**AMENDMENT TO REGULATING PLAN
& SUBDIVISION STAFF REPORT****Date: December 15, 2016****NAME**

Precision Engineering Subdivision

LOCATION400 St. Louis Street
(Area bounded by St. Louis Street, North Hamilton Street,
North Franklin Street, and St. Anthony Street.)**CITY COUNCIL
DISTRICT**

Subdivision to create 1 legal lot of record from 6 metes-and-bounds parcels, and an amendment to the regulating plan to change the regulating sub-districts from SD-WH and T-5.1 to SD-WH to eliminate split zoning.

SITE PLAN

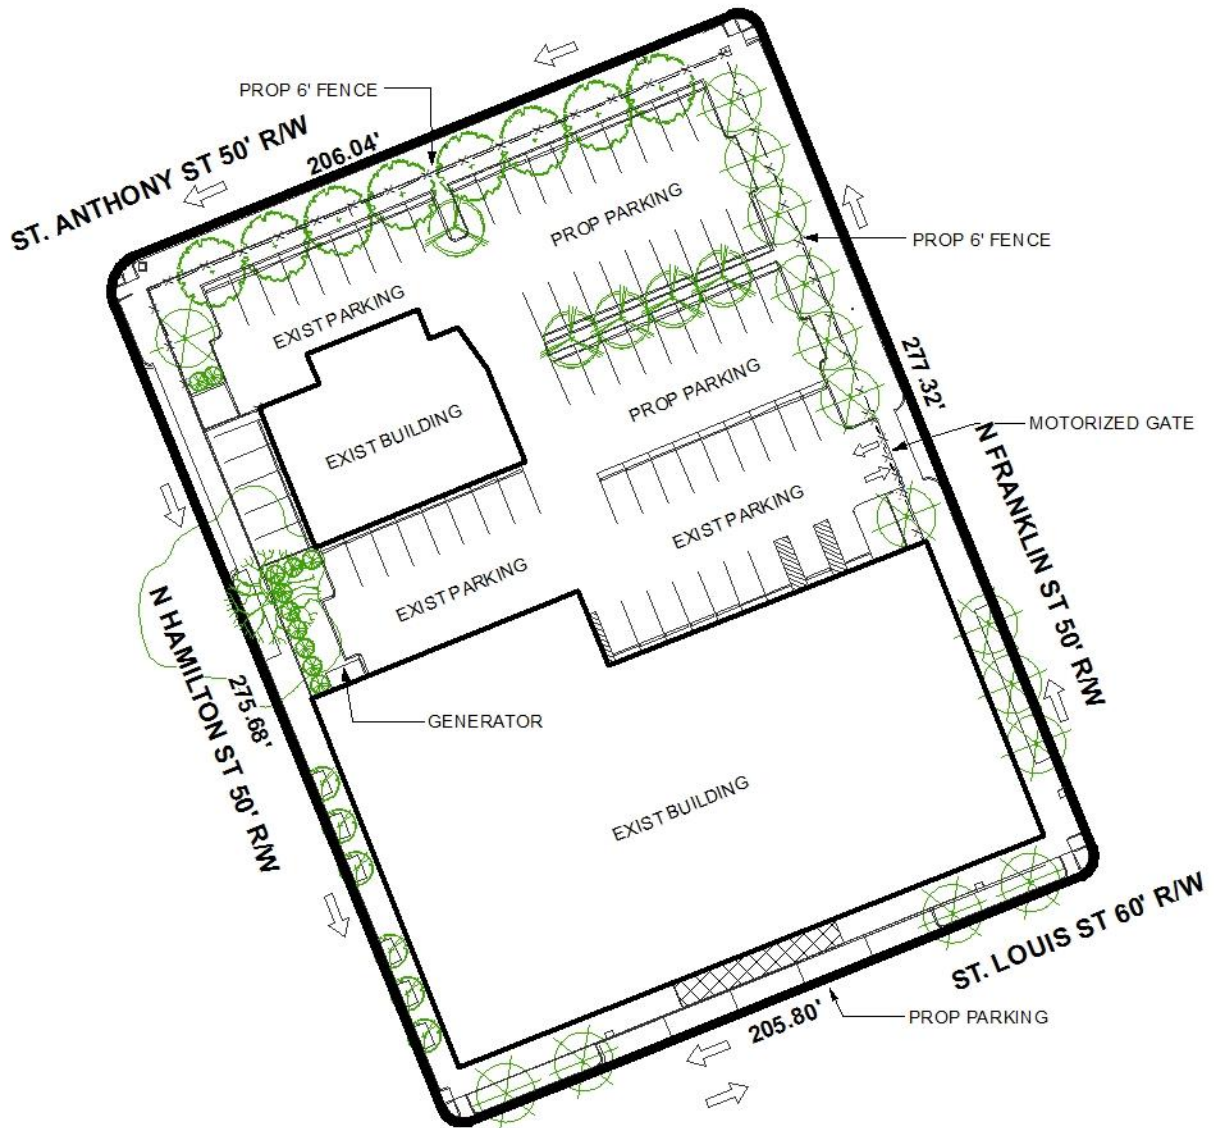
The site plan depicts a total of 69 parking spaces on site; however staff can only identify 68 on-site parking spaces. The site plan should be revised to depict the correct labeling of the number of on-site parking spaces.

A dumpster with enclosure is shown on the N Hamilton Street frontage. It appears that servicing will require the use of the right-of-way: such is not allowed by Section 64-3.I.12.(b)(2), and will require a variance approval to be allowed as proposed. Additionally, the curb-cut for the dumpster and the abutting fire parking spaces along N Hamilton Street exceed the 25' width limit, thus either a variance will be required or the site should be redesigned to comply with the Zoning Ordinance requirements.
